**Addendum No. 1**

**Subject:** General Louis Wagner Middle School Culinary Art Suite Renovation  
SDP Contract Nos. B-022C, B-023C, B-024C, B-025C

**Location:** General Louis Wagner Middle School  
1701 W Chelton Ave  
Philadelphia, Pennsylvania 19139

**This Addendum, dated 1 of April, 2021, shall modify and become part of the Contract Documents for the work of this project. Any items not mentioned herein, or affected by, shall be performed strictly in accordance with the original documents.**

DRAWING NO.  
**E - 100**  
 SHEET 16 OF 23

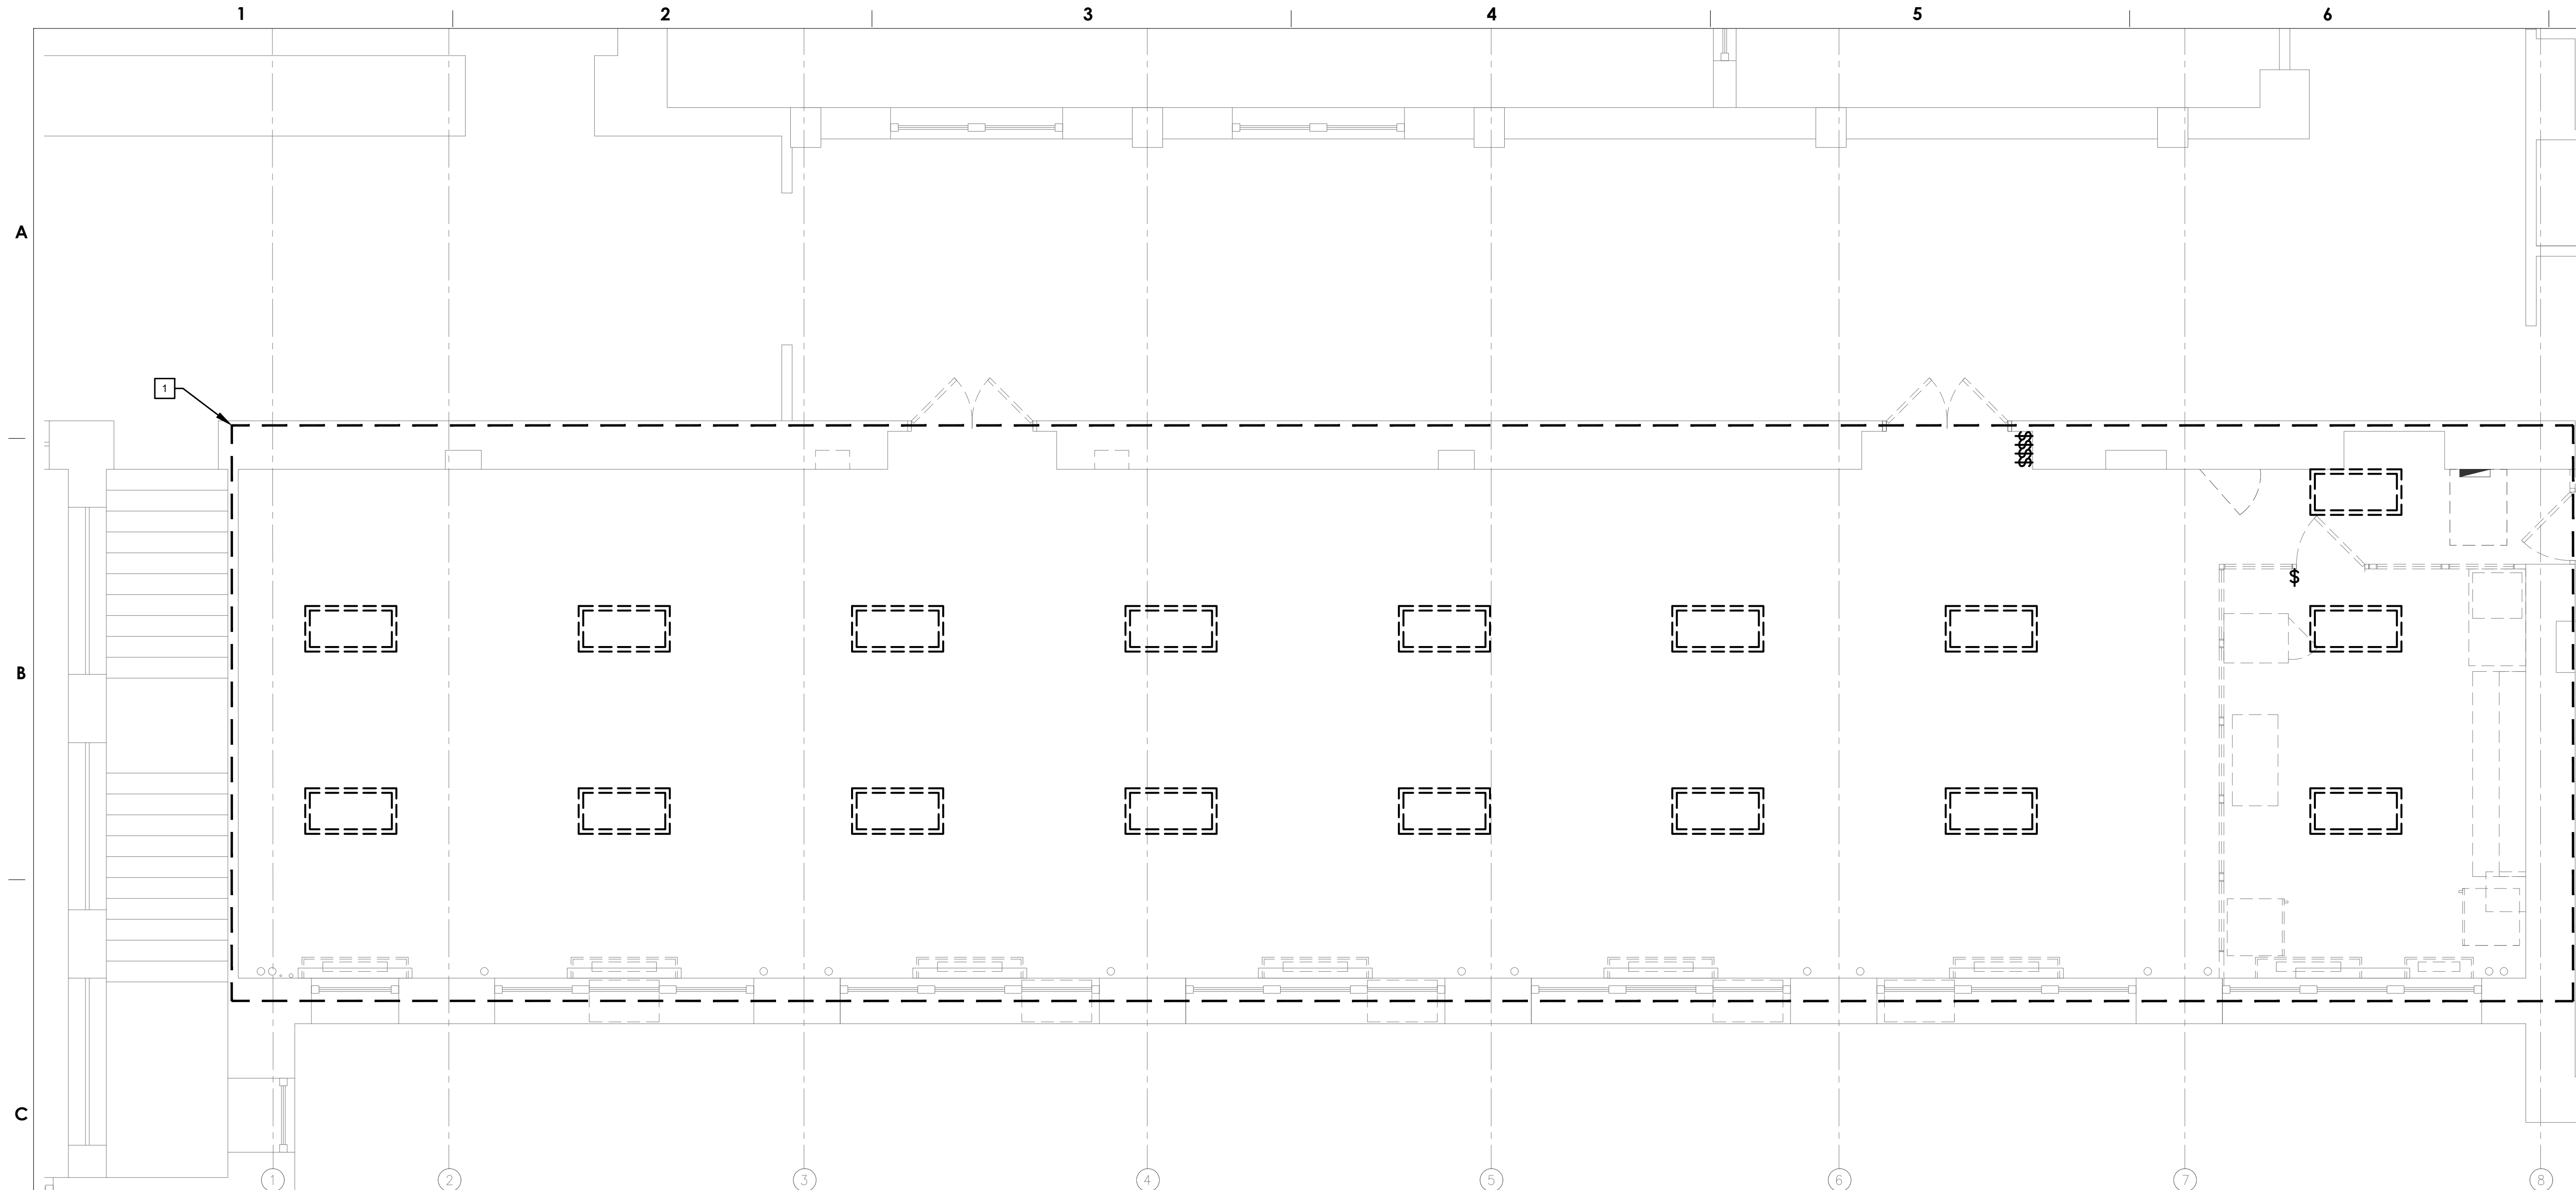
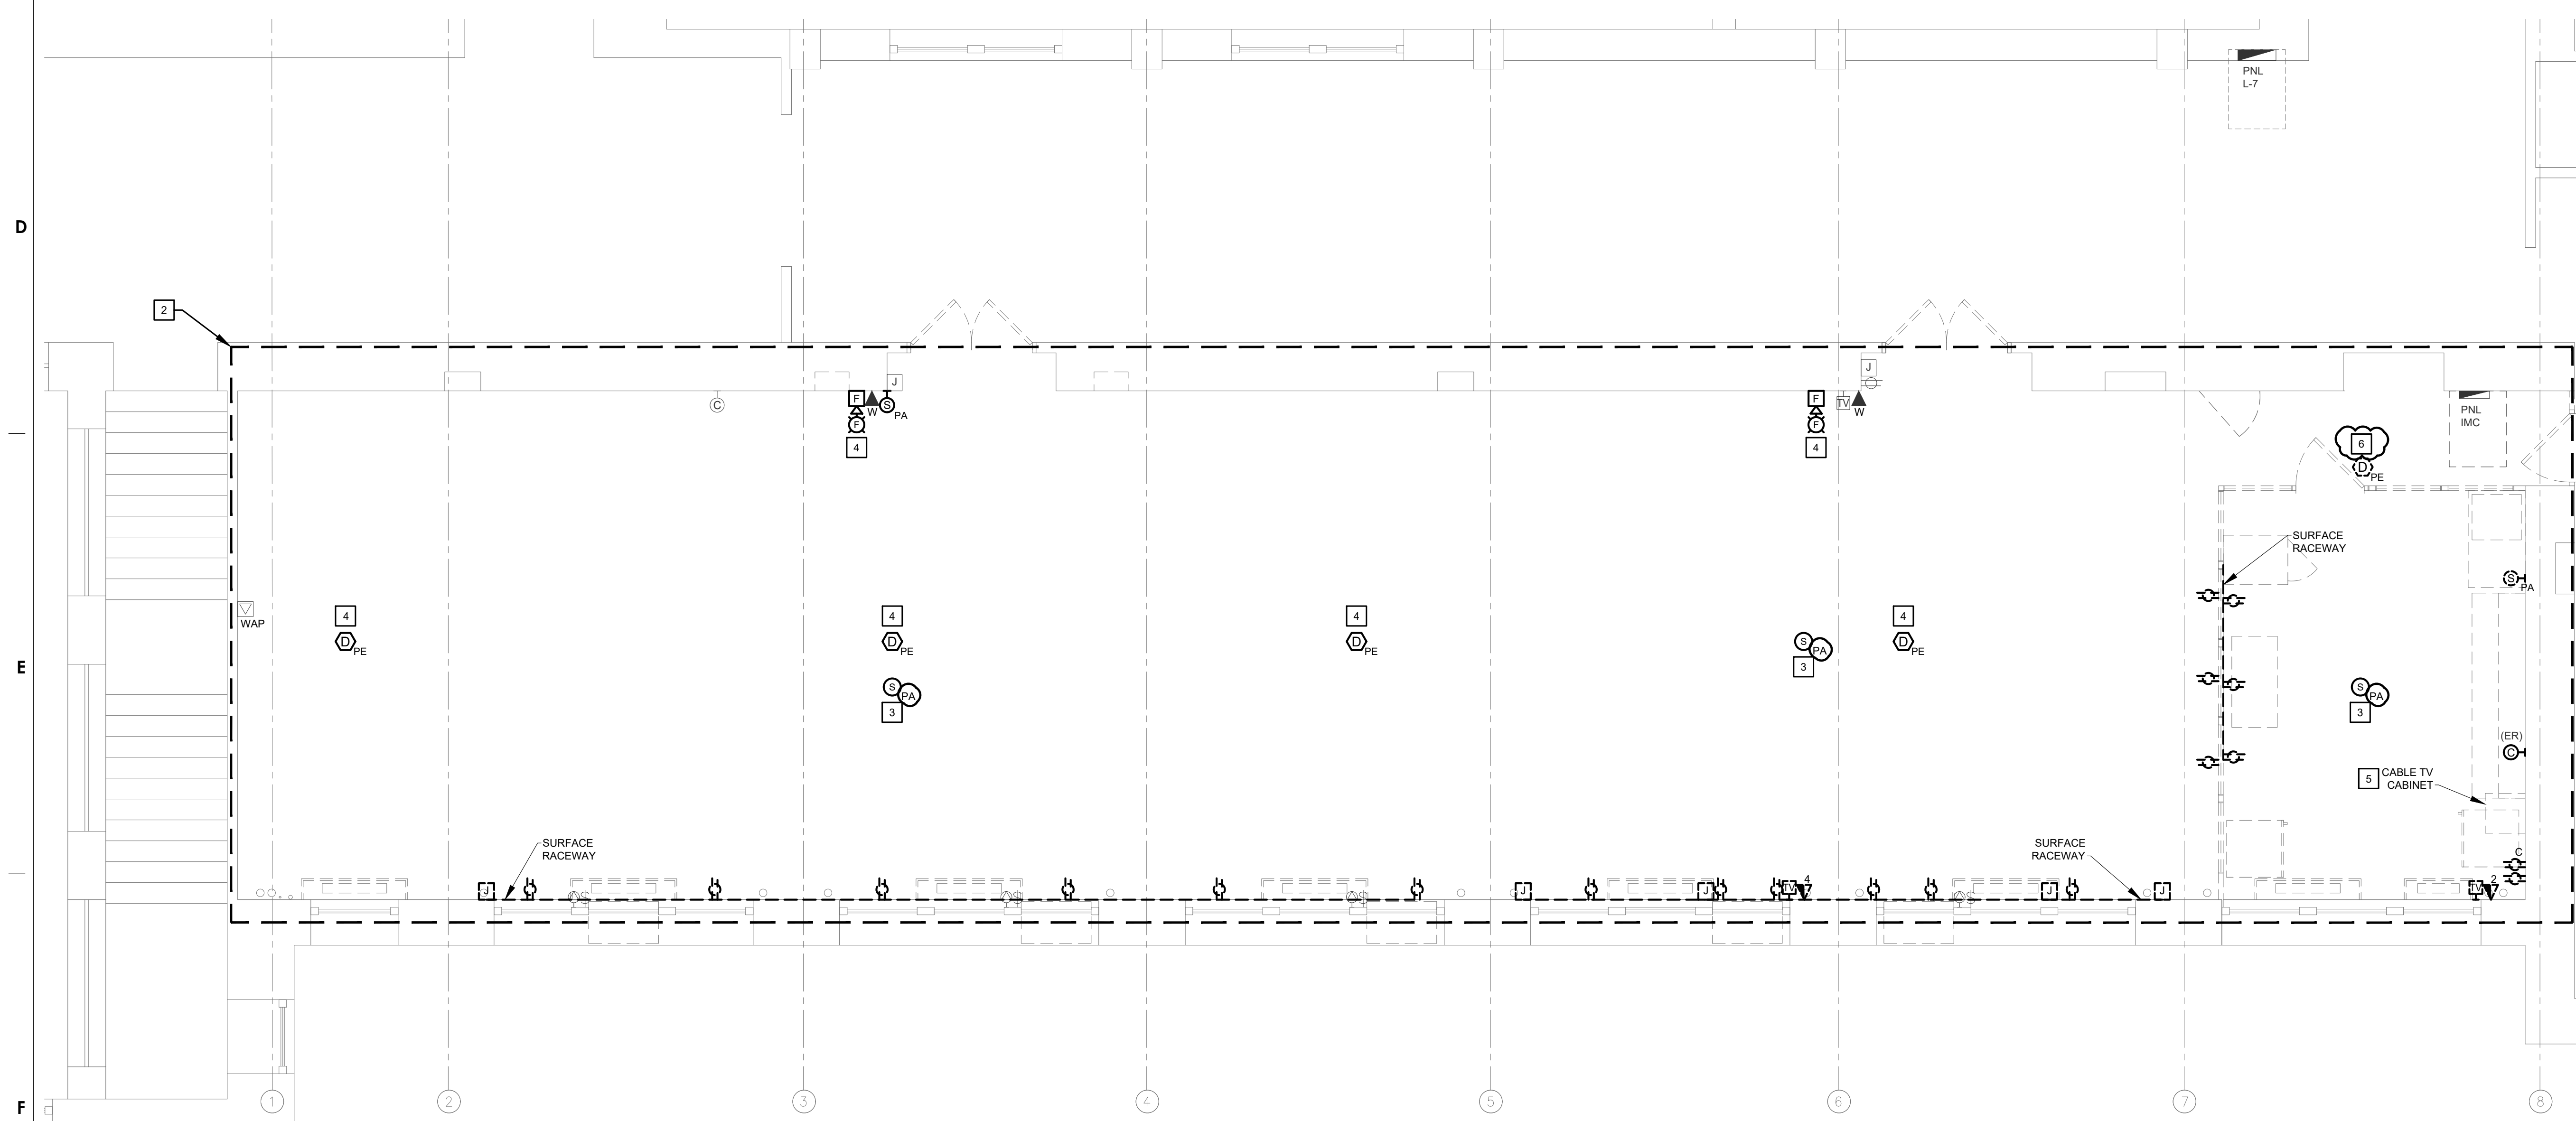
#### **Drawing: E-100 Room 209 and 210 Electrical Demolition Plans**

- c. Added sheet note #6.
- d. Added tags to ceiling mounted speakers "PA" (public address) for clarification.

Question 6: On Drawing E-100, there are three (3) fire alarm speakers with a note 3 next to them. On E-300, there are five (5) fire alarm speakers. Are there two (2) new devices or are they relocated from another area of the room?

**Answer 6: E-100 includes ceiling mounted PA speakers. Drawing E-300 is revised to include this re-installation. Heat detectors shown in E-300 are all new, to be installed in place of existing smoke detectors. See sheet note 5. Please refer to legend for symbols identification.**

**1 ROOM 209 AND 210 LIGHTING NEW PLAN**  
SCALE: 1/4" = 1'-0"

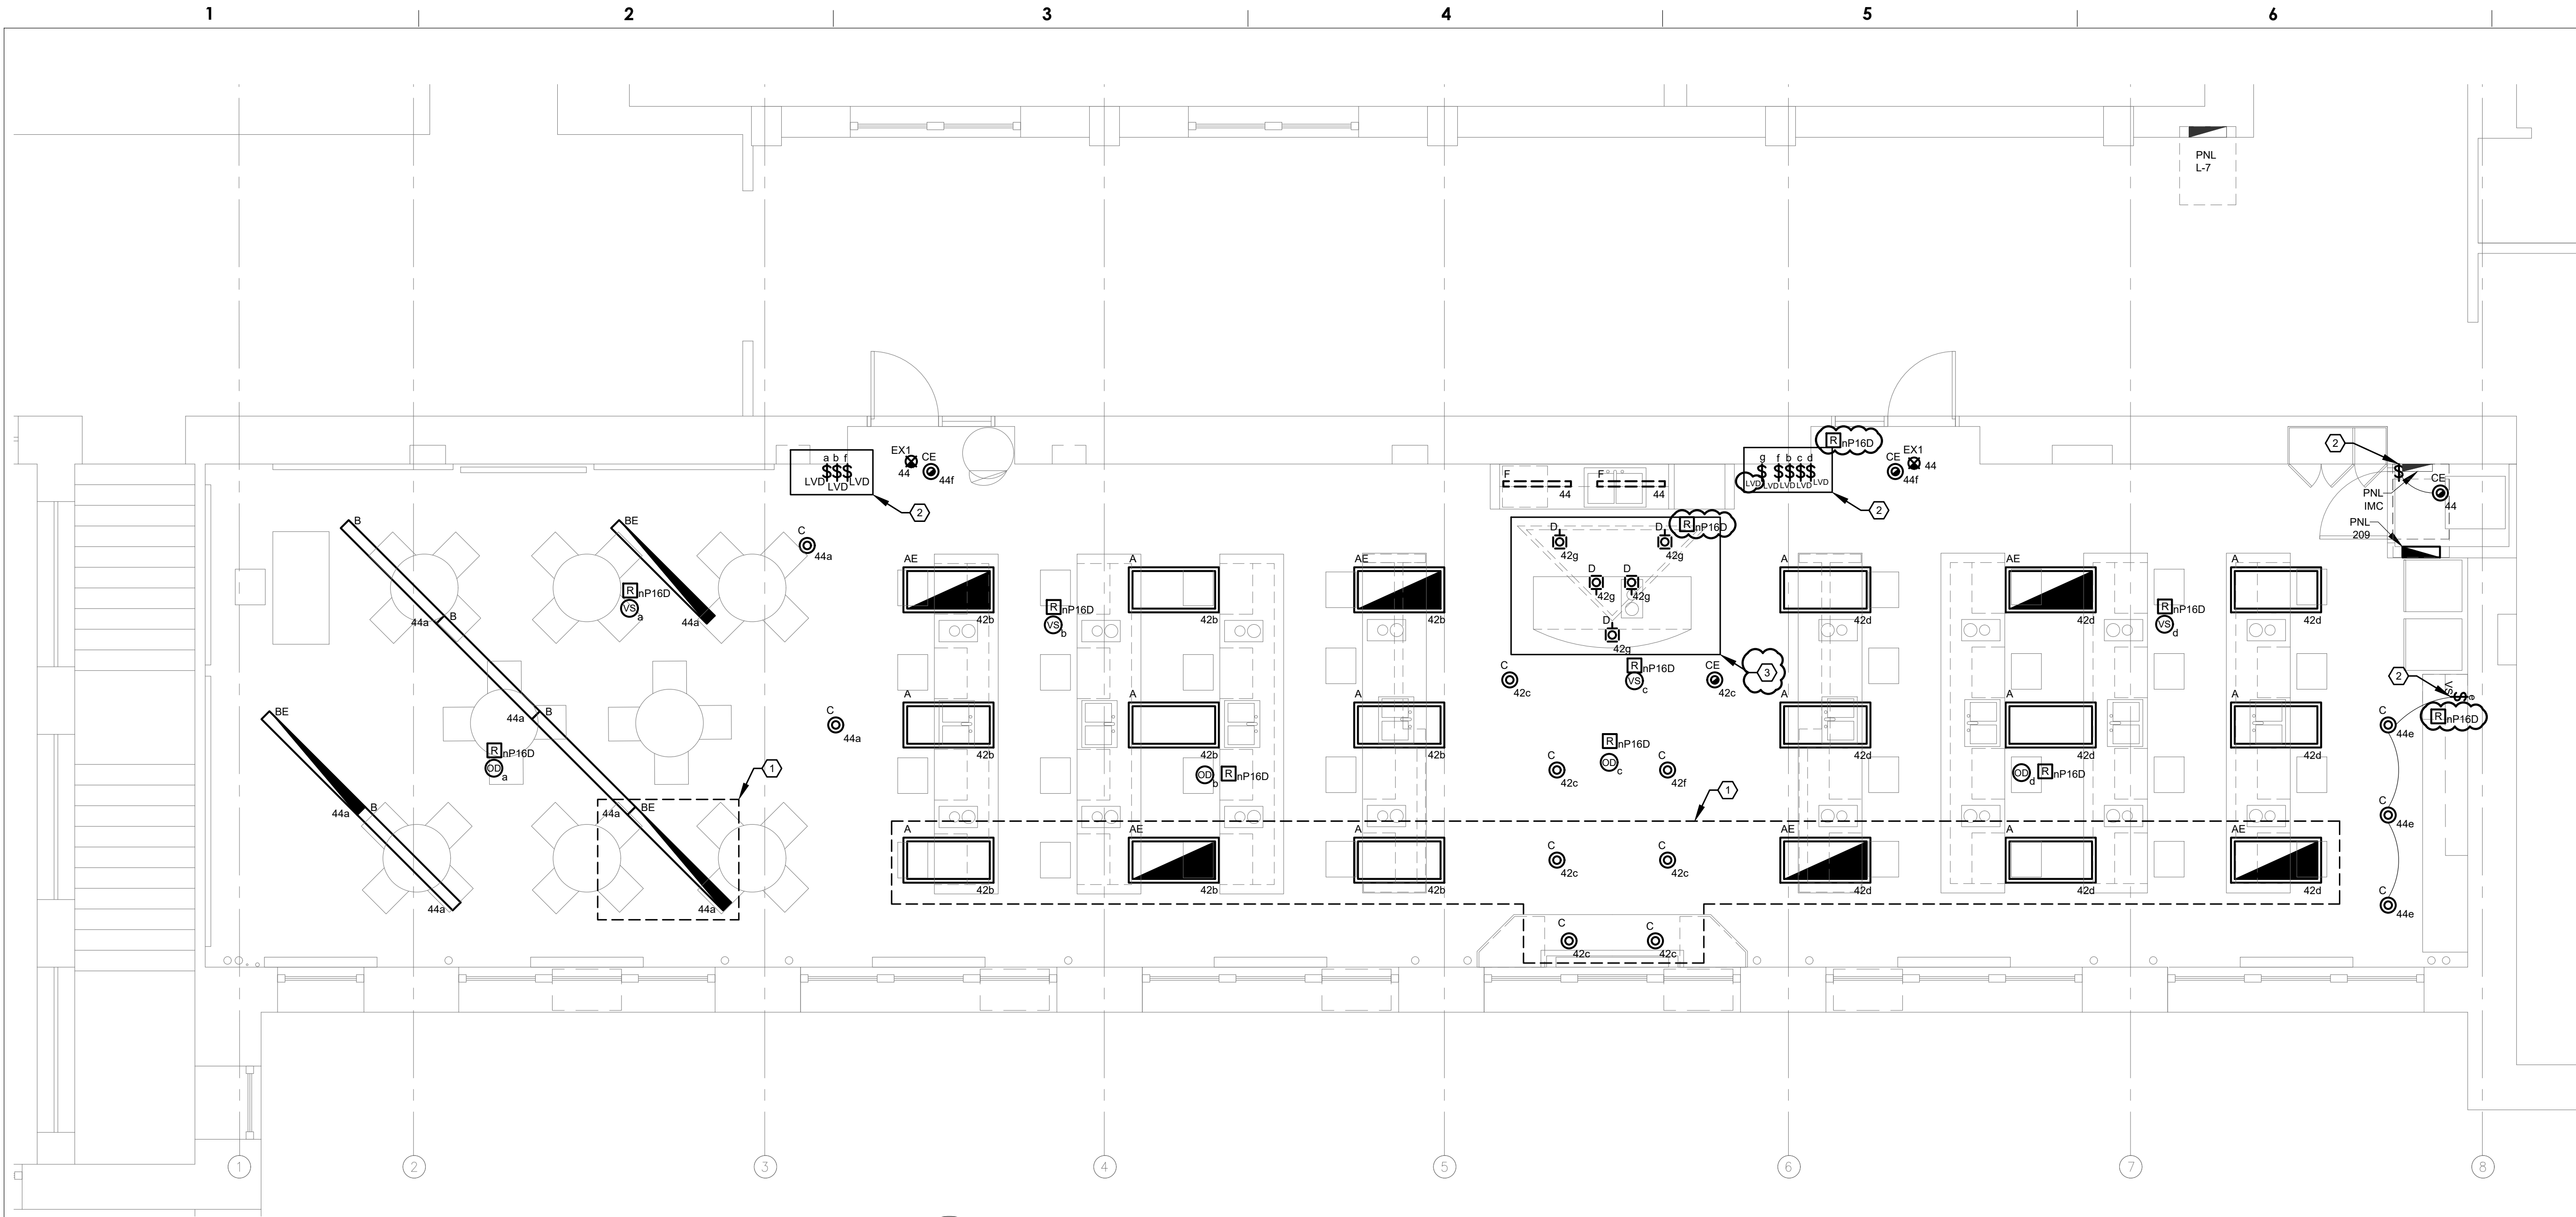
#### **Drawing: E-200 Room 209 and 210 Lighting New Plan**

- a. Added relays for switch zone e, f & g.
- b. Changed switch g to \$<sub>LVD</sub>.
- c. Added Sheet note #3.
- d. Updated mounting for fixture type D in lighting fixture schedule.

Question 1: The basis of design for dimming switch symbol "\$D" controlling zone g has not been specified. Was there a typo for this symbol on the plans and it was meant to be shown as symbol "\$LVD", which is a digital dimmer? Or was this dimmer meant to be a non-digital dimmer for some reason? Please clarify design intent.

Question 7: On Drawing E-200, the power pack relays for zone E & F shown on drawing E-520 are not shown. Are they required?

**Answer 1: Switch shall be \$<sub>LVD</sub> – see addendum 1.**

**Answer 7: Relays are required, refer to updated drawing E-200, addendum 1.**
